LOCATION Sharon Road Underpass

SHARON ROAD UNDERPASS
Hwy. 402 Dist. 2 London
W.P. 41-66-11 Site 19-541

FOUNDATION INVESTIGATION REPORT
for

Subject: Sharon Road Underpass,
W. P. 41-66-11, Site 19-541,
Highway 402, District 2.

ABUTMENT ON COMPACTED FILL SHOWING GRANULAR 'A' CORE

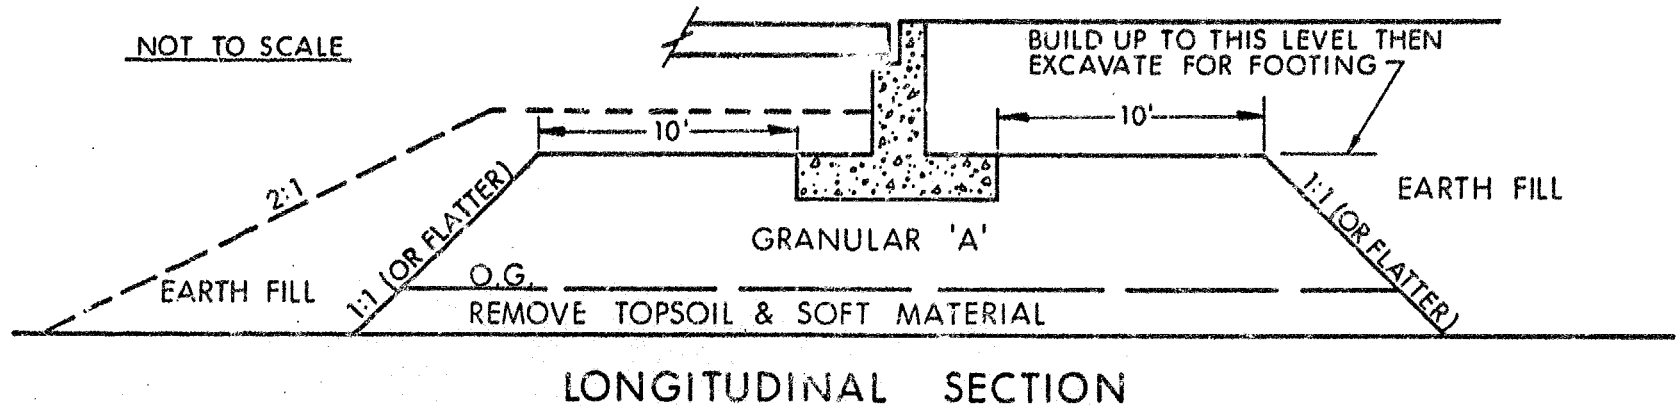
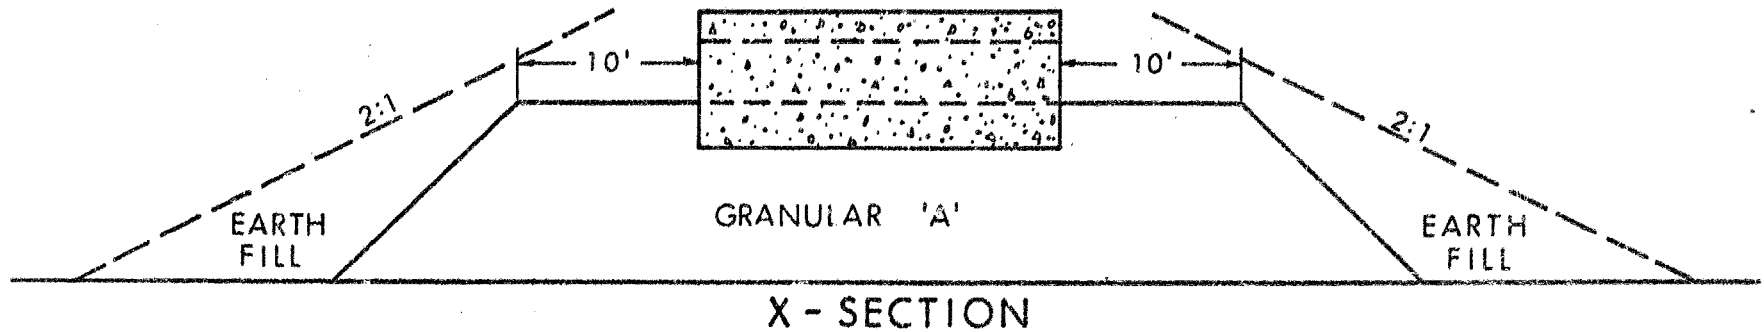
As an alternative, the abutments may be supported on spread footings placed on well compacted G.B.C. Class 'A'. A net safe design load of 2.5 t.s.f. may be assumed. For calculations of sliding resistances, a friction coefficient of 0.6 may be assumed to apply between the footing and G.B.C. Class 'A'. A detailed construction scheme is outlined on Fig. 1 of the appendix.

BORE HOLE LOCATIONS & SOIL STRATA

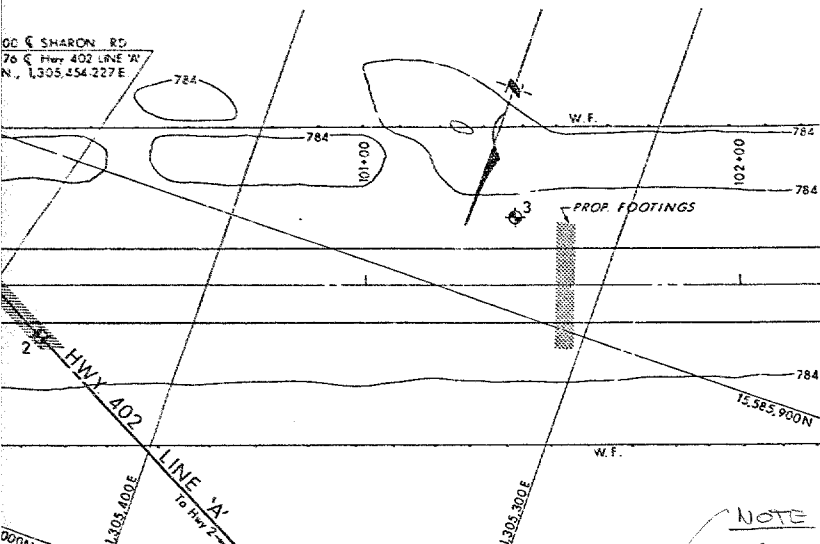
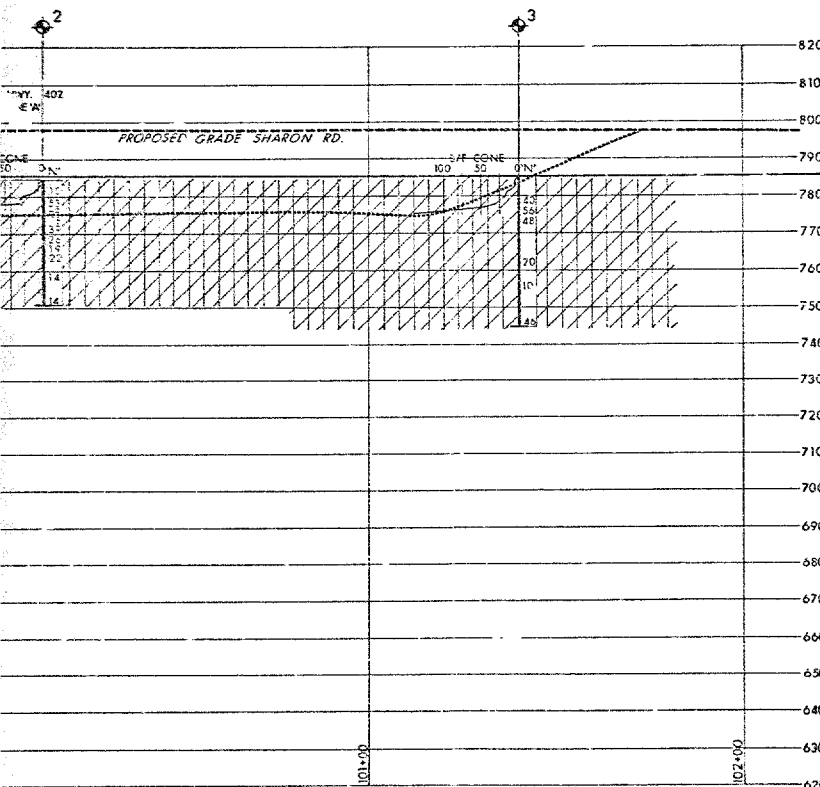
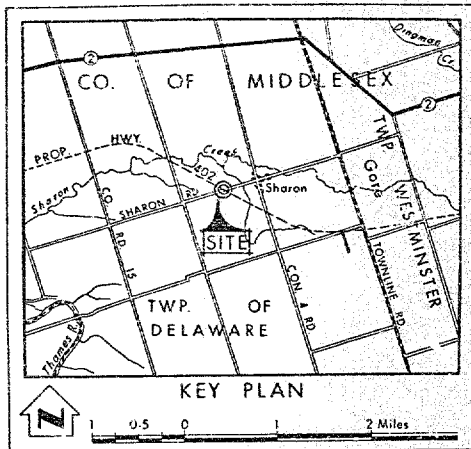
Please add the borelog for B.H. #4 to your report and replace the foundation drawing with the revised copy enclosed.

REVISIONS	DATE	BY	DESCRIPTION
Aug/75	G.P.	B.H. 4	ADDED ON PLAN & PROFILE

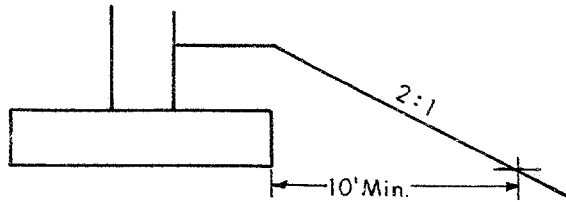
The lowering of the grade by 8 feet as indicated in your letter of May 6, 1975 will remove most of the desiccated crust at this site. This will necessitate the following changes in the foundation recommendations:

The center pier may be supported on a spread footing type of foundation at approximate elevation 870 with a design load of 2 tons per square foot. Total settlement of approximately $1\frac{1}{2}$ inches is anticipated.

The abutments may be supported on spread footings at approximate elevation 881 with a design load of 4 tons per square foot. The front face of the footing must be placed at least 10 feet from the cut slope as shown below.

Total settlement for the abutments is anticipated to be approximately 2 inches.

I wish to point out that the footing elevations given for this structure in my memo of May 23, 1975 were in error. Elevation 870 for the center pier footing should read 770 and the abutment foundations will be founded at 781 not 881.

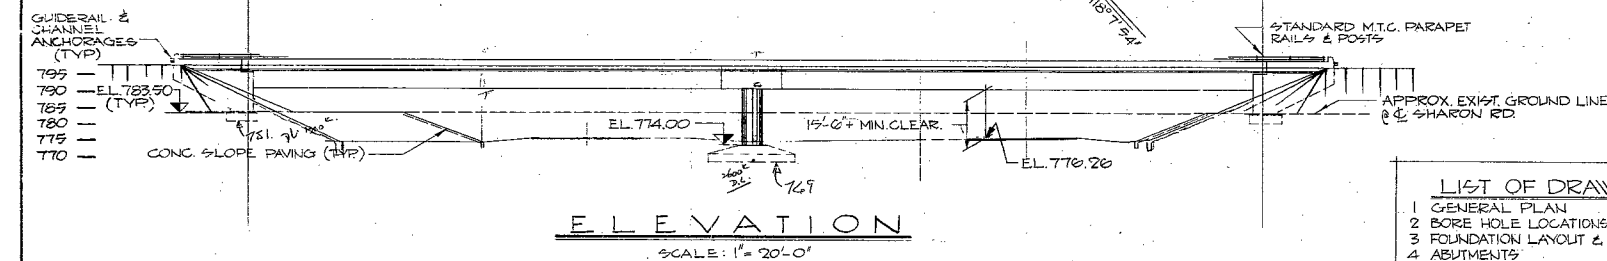
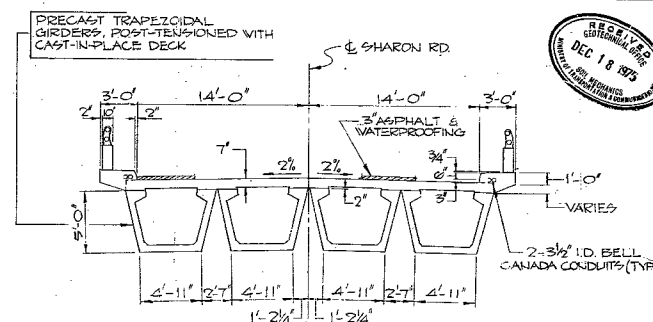
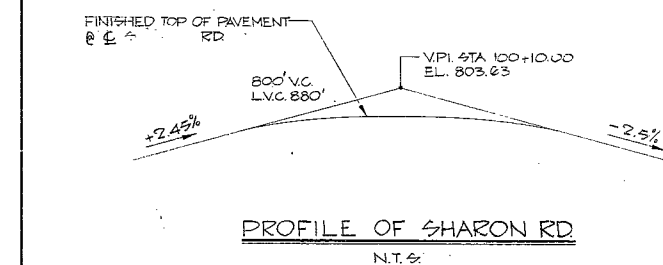
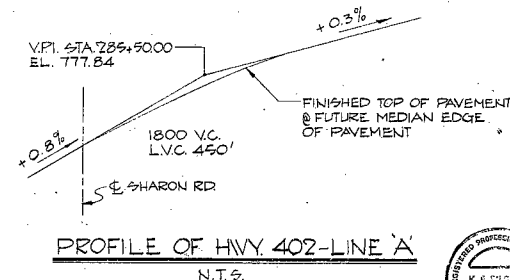
Based on the information supplied by Mr. R. W. Bratty, Project Manager of Giffels, Davis & Jorgensen, the General Plan of contract drawing sheet one has been revised to show the location of culverts, storm sewers and the grading contours. Consequently the bridge material list and Note to Regional Planning and Design Office should be revised as follows:

Change item (d) "Water for compaction... (The approximate quantity of Granular Backfill is to read 235 cu yd)".

Change "Cement (Bridge) - ton - to read 257".
Delete Protection Board for Bridge Waterproofing.

Enclosed for your record is the half size print of drawing No. 19-541-1, please supersede the previous print of sheet one.
